1 Q. **Reference: 2026 GRA – Volume I, Schedule A-II: Actual and Forecast Electricity Requirements**
2 **for 2019–2027**

22 In 2019, NL Hydro received approval from the Board to construct the Muskrat Falls to Happy
23 Valley Interconnection (P.U. 9 (2019)), which was projected to increase the transmission system
24 transfer capacity to Labrador East from 77 MW to 104 MW.

Chart 1: System Average Interruption Duration Index by Customer

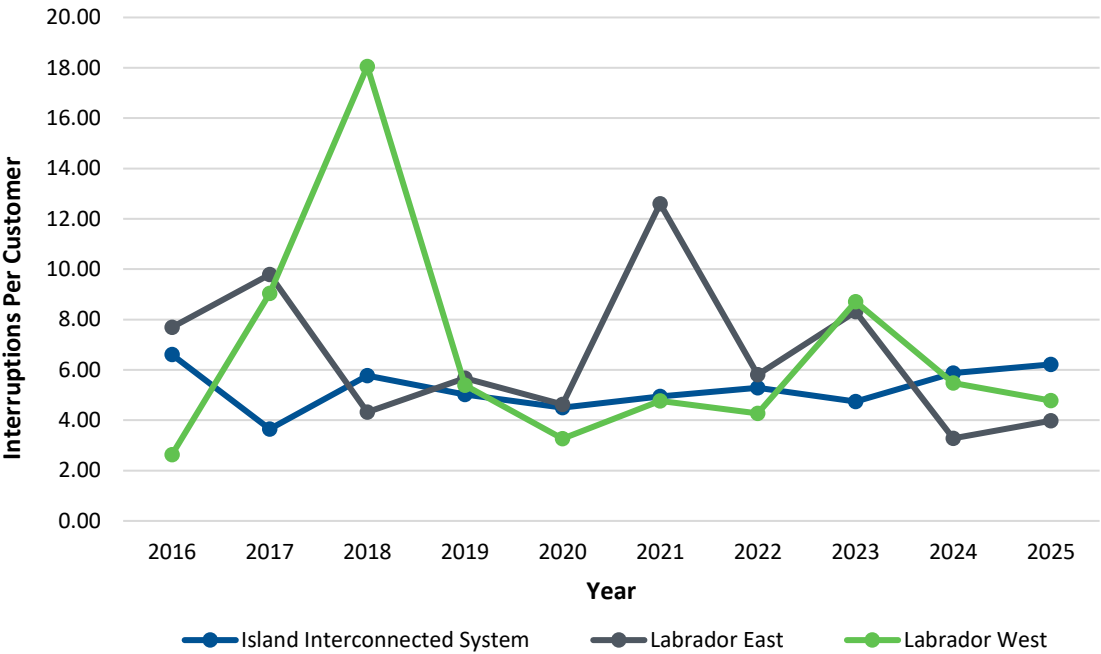
3 **c)** Please provide the annual System Average Interruption Duration Index (SAIDI) and
4 System Average Interruption Frequency Index (SAIFI) for the years since the Muskrat
5 Falls to Happy Valley Interconnection became operational and five years prior to that
6 date for:

7 **i.** Customers serviced by the Muskrat Falls to Happy Valley Interconnection (i.e.,
8 Labrador East);

9 **ii.** Labrador West; and

10 **iii.** the IIS.

1 c) Please refer to Chart 1 and Chart 2 for the requested information. These charts were

2 developed using the respective customer counts and include all outage events.
